Spring Street 24th to 36th Pipelines, DPW 12-12F4

C) Answers to Questions Received

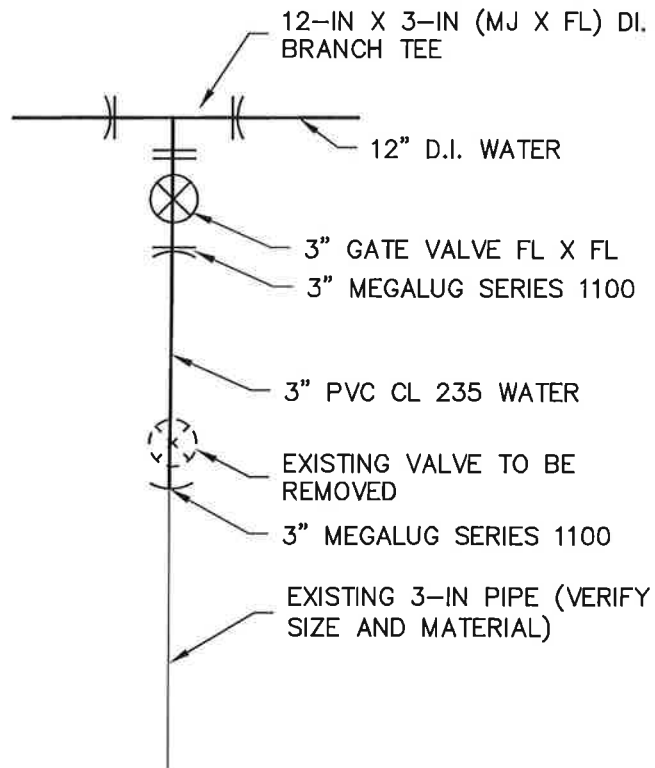
4. On Sheet 17, there is a Note 11 identified at a Manhole on the top left section of the page. Please see the snippet. Is this an accurate call out? If so, how many feet of pipe are we to install? Please advise.

- a. The callout is correct, and the plans identify 45 lineal feet to be replaced (plus or minus).

3-INCH TIE OVER TO EXISTING

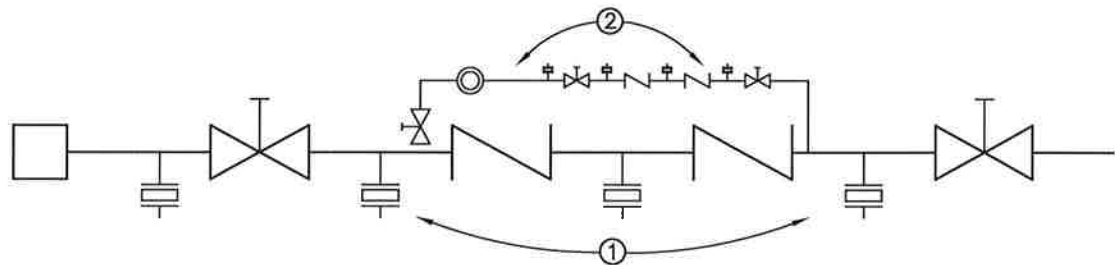
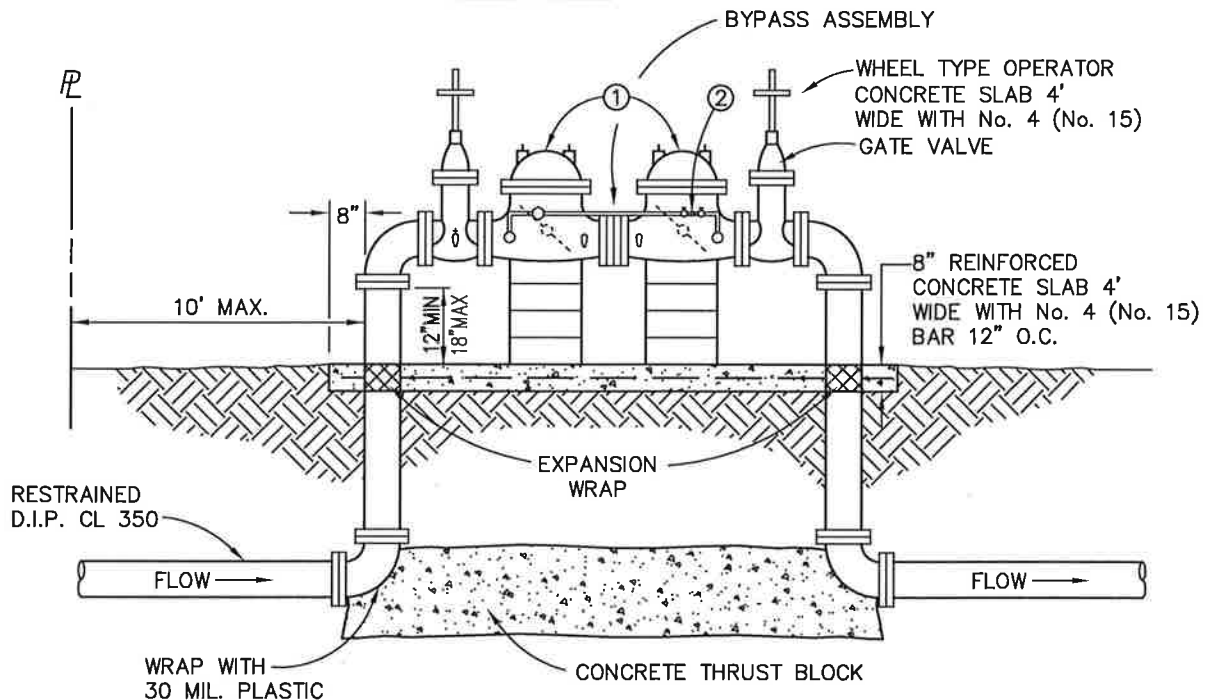
1. On Sheet 9, Note 51, we are to provide a 3" tie over – including all piping, fittings, valves, and appurtenances – Please provide a detail of this tie over.

See Attachment No. 1, which contains a detail for the 3-in tie over.
